CHAPTER 3 – REVISIONS, CLARIFICATIONS, AND CORRECTIONS TO THE DRAFT EIR

670 Mesquit

Revised Figure II-5
City and Amtrak Easements

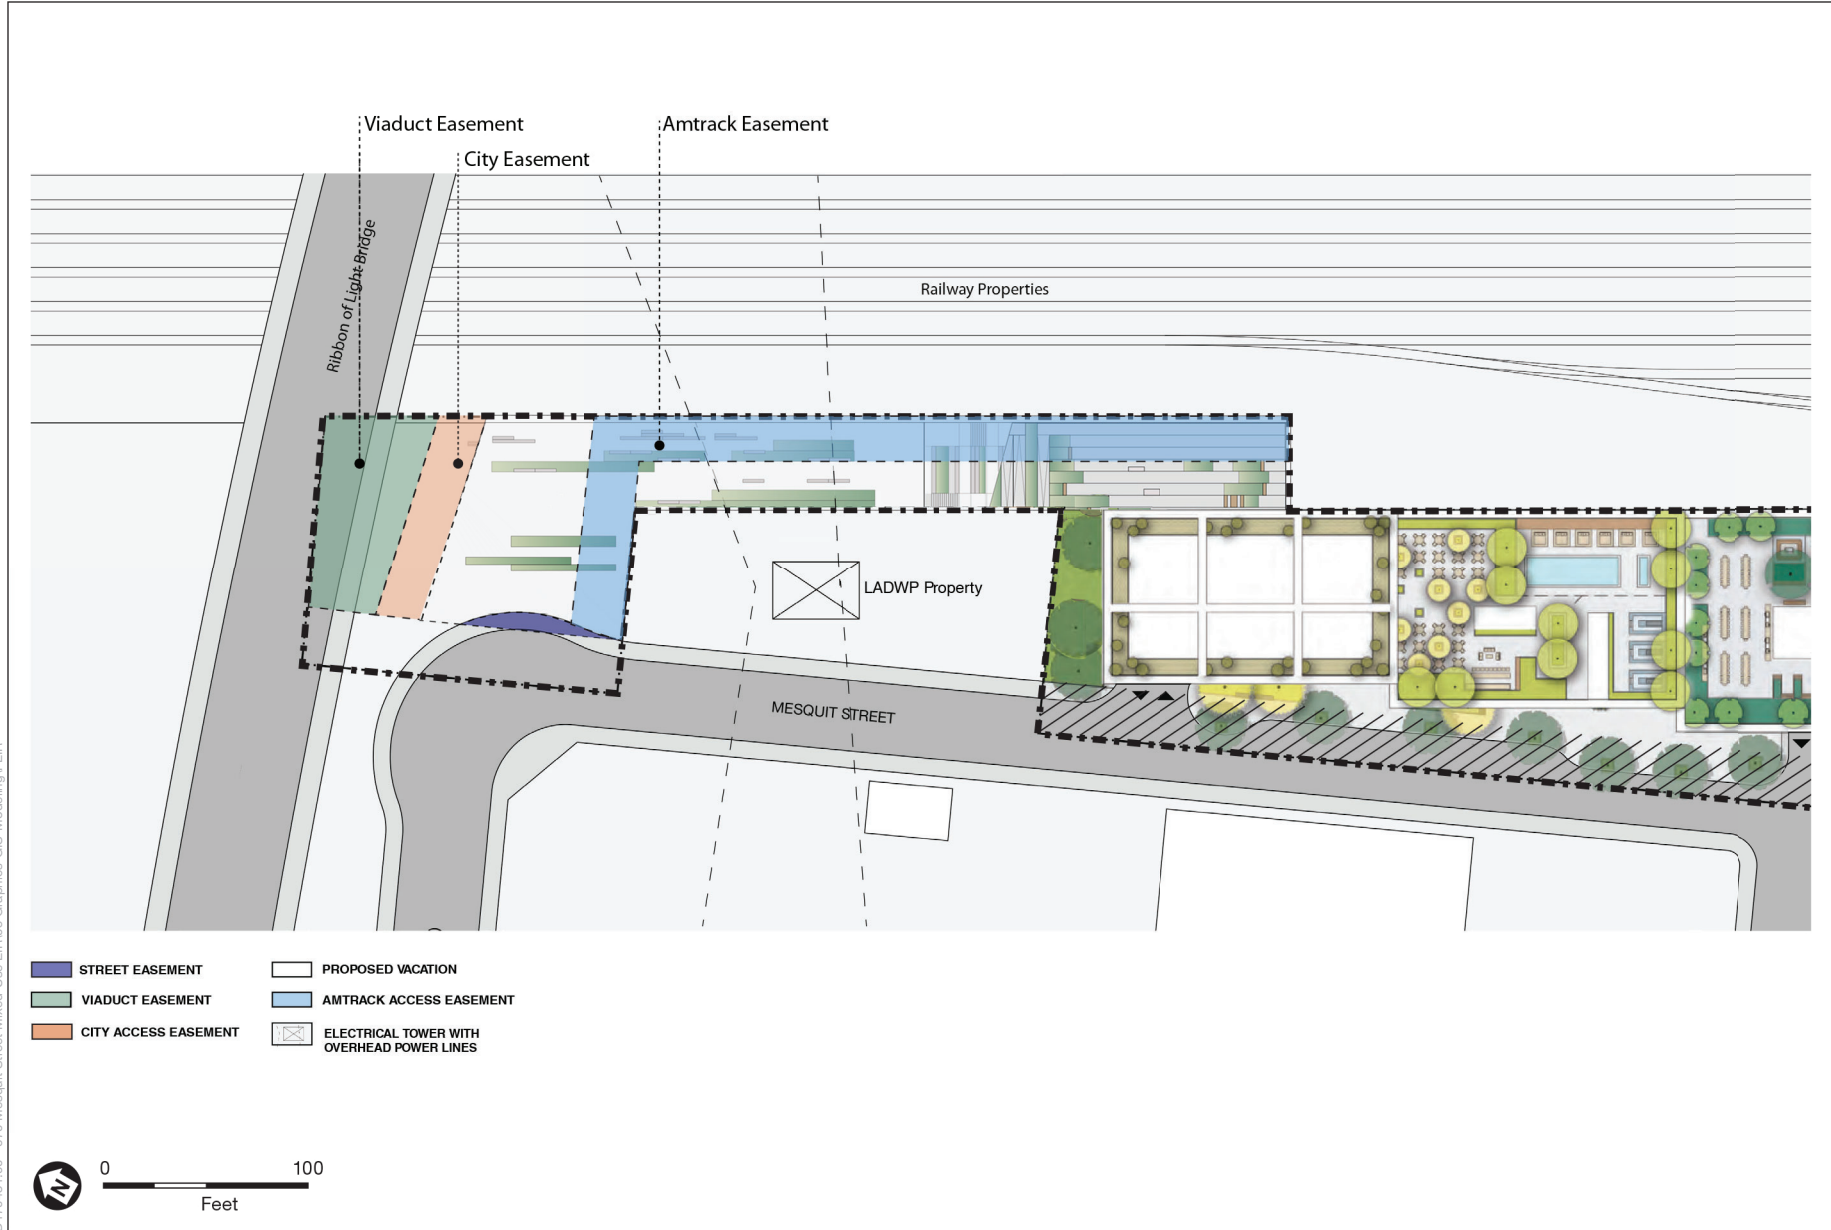
2. Page II-13, Subsection 3, Existing Project Site Conditions, revise the 2nd paragraph and update Figure II-5, City and Amtrak Easements, on page II-15 as shown below. Revised Figure II-5 removed the previously included “Park Option” area. The City and Applicant had agreed to an Option for a Park Easement that would serve as an extension of the City’s proposed Sixth Street Park, Arts, River, and Connectivity (PARC) Improvements, however, the City did not exercise the Option and that area will not be utilized for the proposed PARC.

Viaduct Easement, Maintenance Access Easement, and Street Easement in connection with the Ribbon of Light Bridge. As shown in Revised Figure II-5, depicted future landscape trees have been located to avoid overhead power transmission lines. However, as shown in Revised Figure II-6, the former “Park Option” area would continue to be landscaped. The City and Applicant also agreed to an Option for a Park Easement that would serve as an extension of the City’s proposed PARC Improvements. Landscaping would be provided in easement areas at the ground level, would comply with all conditions of the easements, and would be designed to complement the future PARC Improvements. The Applicant also has an easement agreement with Amtrak for maintenance purposes that begins north of the LADWP property and wraps southward around the eastern property line.

The City’s Bureau of Engineering and the Applicant entered into an easement agreement for the City’s use of portions of the northern end of the Project Site. As depicted in **Revised Figure II-5, City and Amtrak Easements**, the Applicant granted the City a

Revised Figure II-6
Conceptual Site Plan

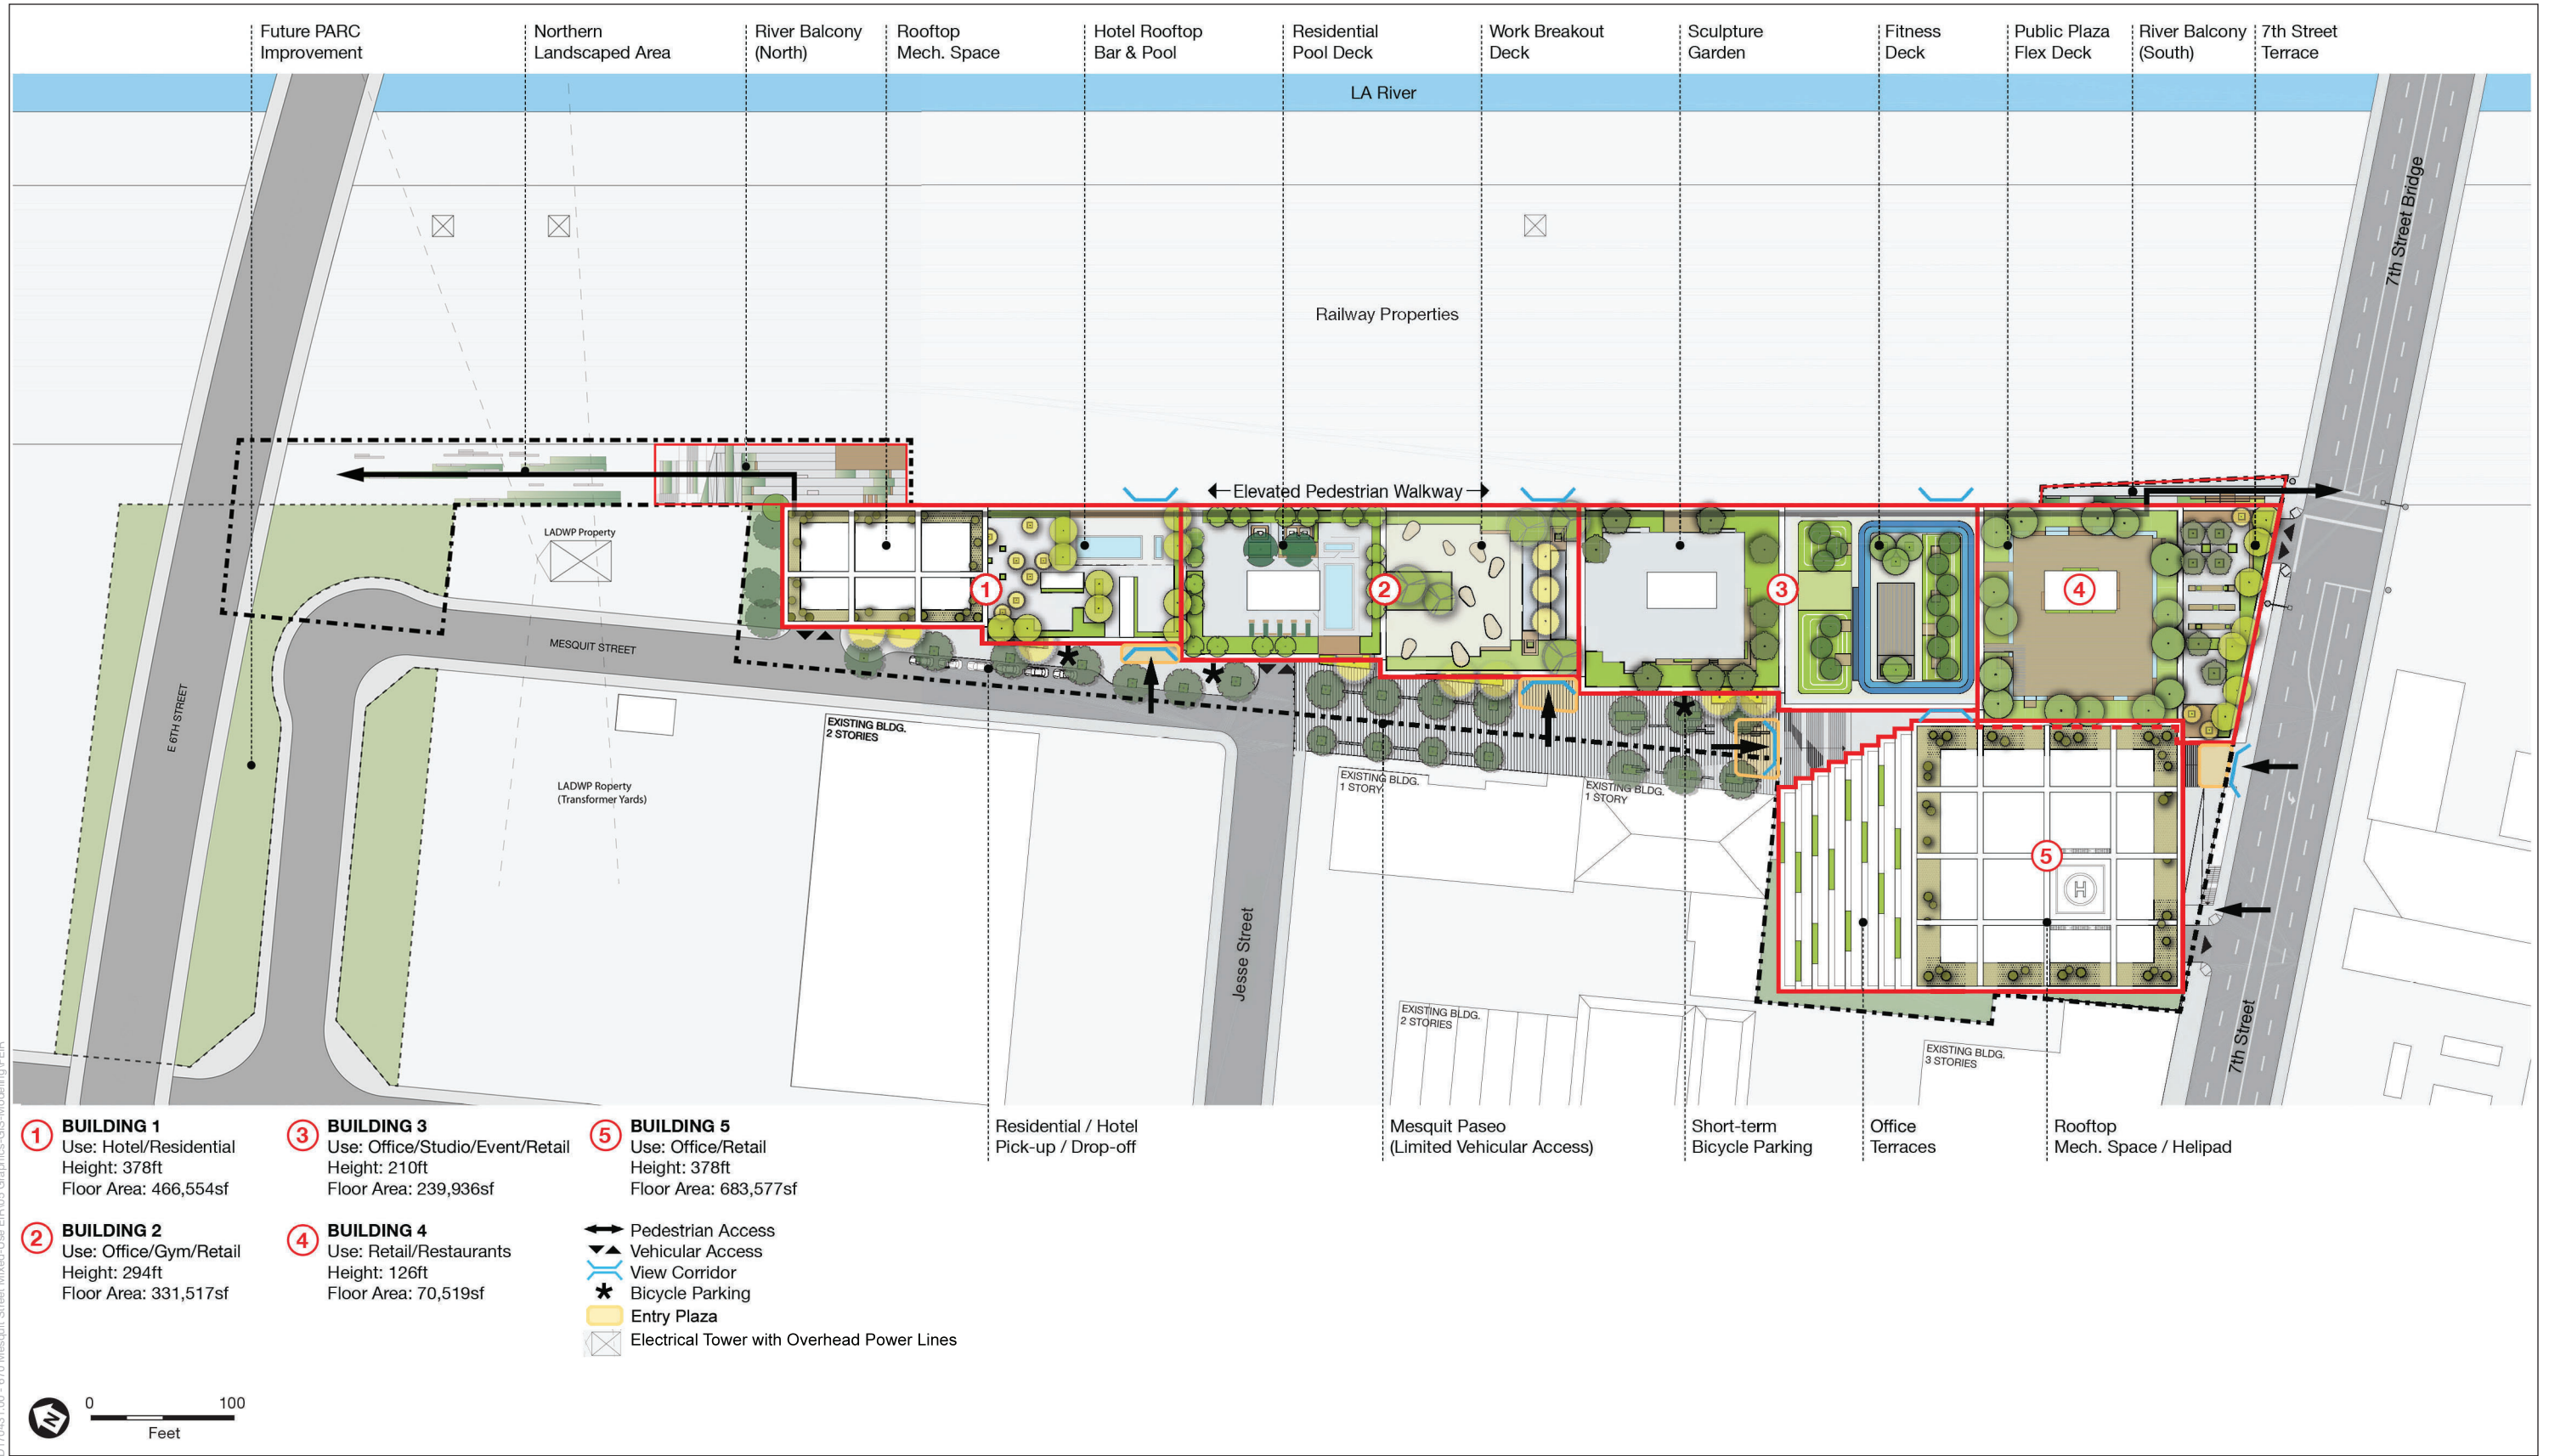
3. Page II-19, Section 6, Description of the Project, subsection a), Project Overview, revise paragraph 3 and update Figure II-6, Conceptual Site Plan, on page II-21 as shown below. Revised Figure II-6 removes the landscaping within the Future PARC Improvement area and landscaping within LADWP property area. Future landscaping in the Future PARC Improvements area will be implemented at the direction of the City. Also, electrical towers with overhead power lines are identified.

The proposed development program is summarized in **Table II-2, Proposed Development Program**, and is discussed in more detail below. A conceptual site plan showing proposed buildings, open space, and vehicular and pedestrian circulation on the Project Site is presented in **Revised Figure II-6, Conceptual Site Plan**. Elevations of the proposed buildings are depicted in **Figures II-7 through II-10, Elevations**.

Figure II-11A
Railway Properties Ownership - Project with Deck Concept

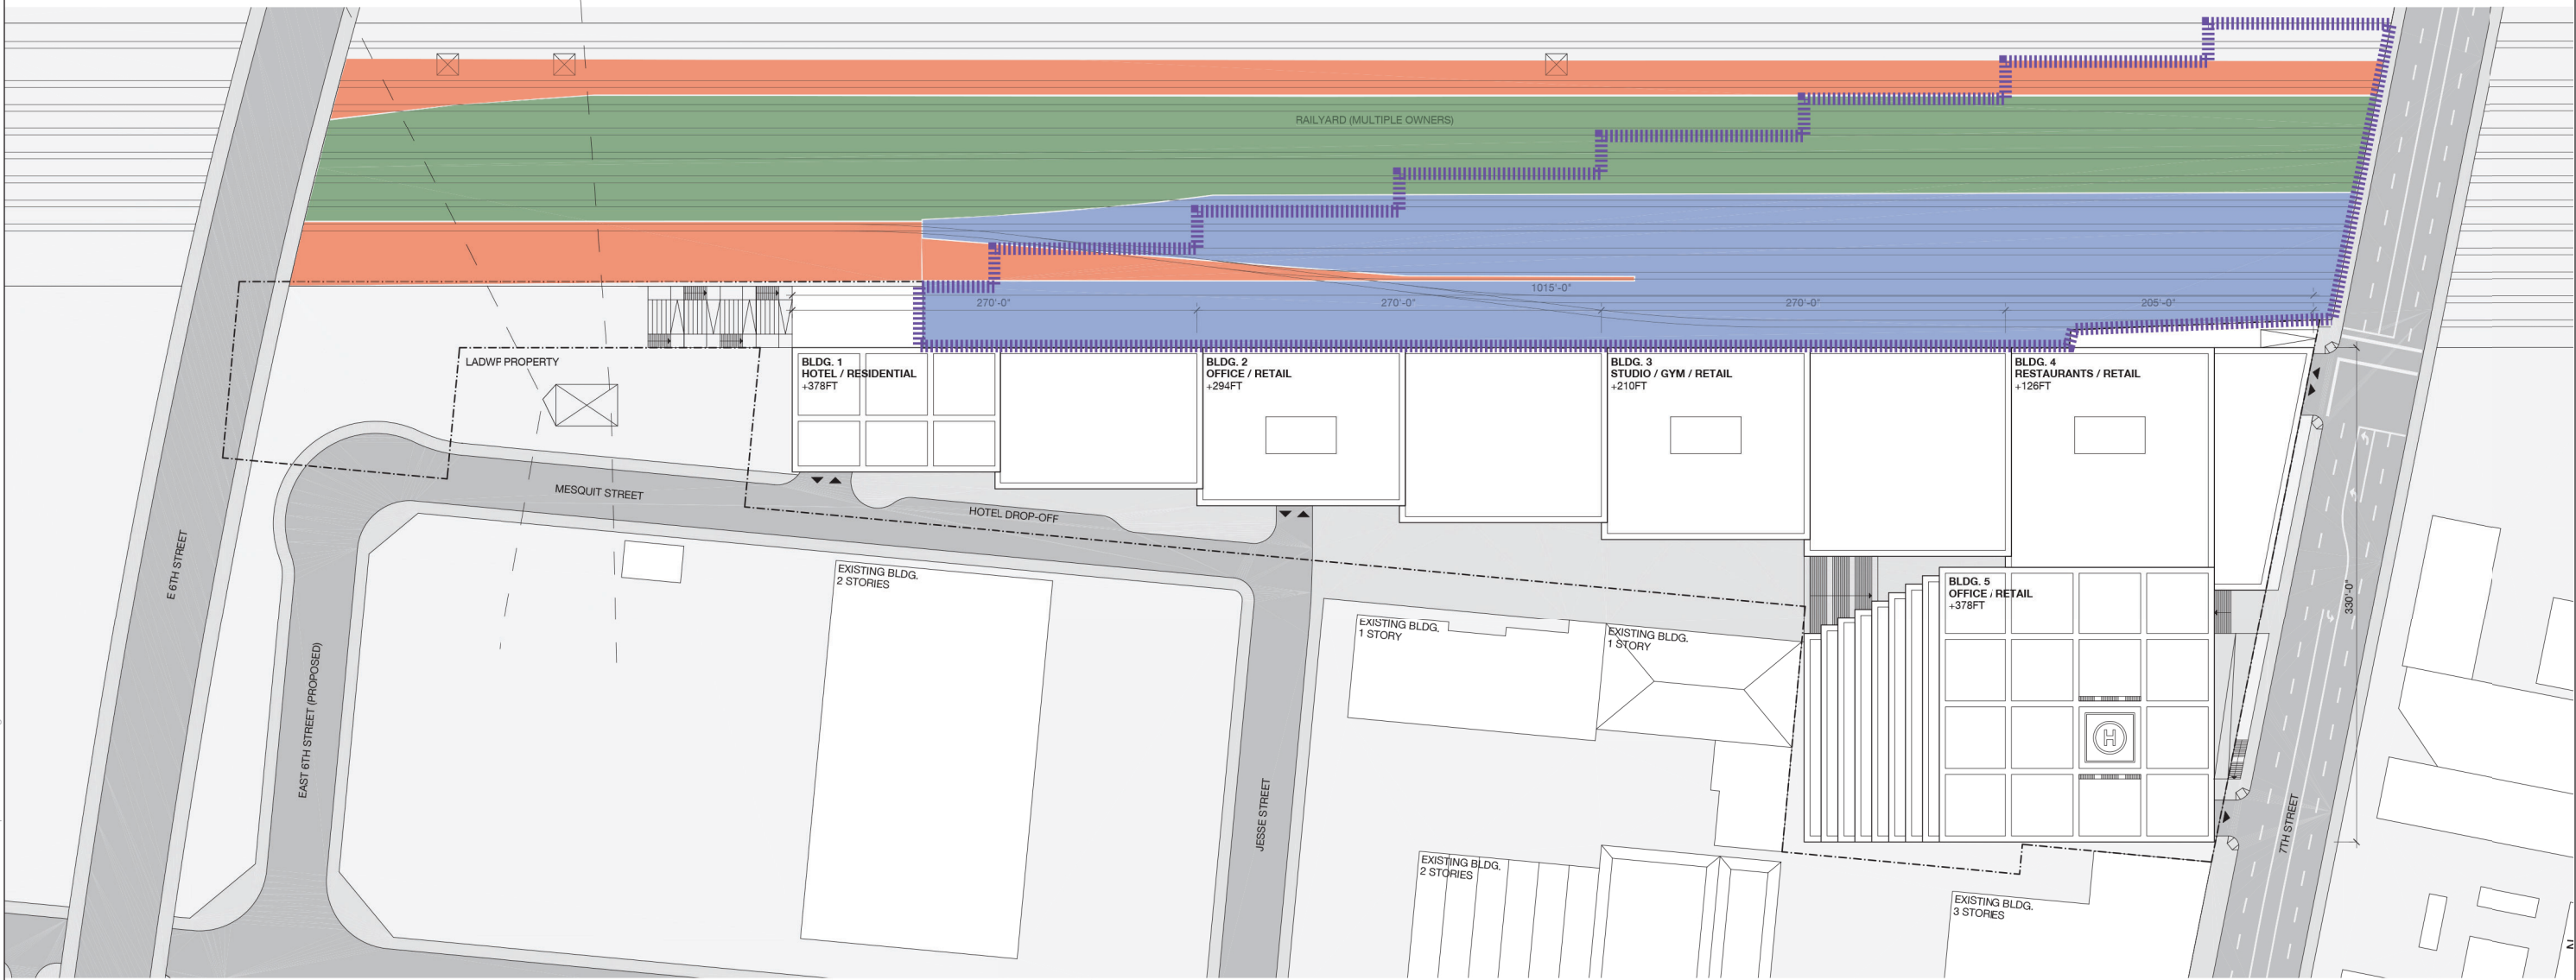
4. Page II-27, Section 6, Description of the Project, subsection a), Project Overview, (1) Project with the Deck Concept, update first paragraph and add Figure 11a, *Railway Properties Ownership – Project with the Deck Concept*, as follows:

Railway Properties Ownership, shows Amtrak, Metro, and BNSF ownership within the Railway Properties. **Figure II-11a, *Railway Properties Ownership – Project with the Deck Concept***, shows Amtrak, Metro, and BNSF ownership within the Railway Properties under the Project with the Deck Concept. **Figure II-12, *Project with the Deck Concept***, shows the Deck configuration. **Figure II-13, *Conceptual Site Plan – Project with the Deck Concept***, includes a Conceptual Site Plan under the Project with the Deck Concept. Construction of the Project with the Deck Concept would only be accomplished if agreements can be obtained with the owners of the Railway Properties and potentially other entities.
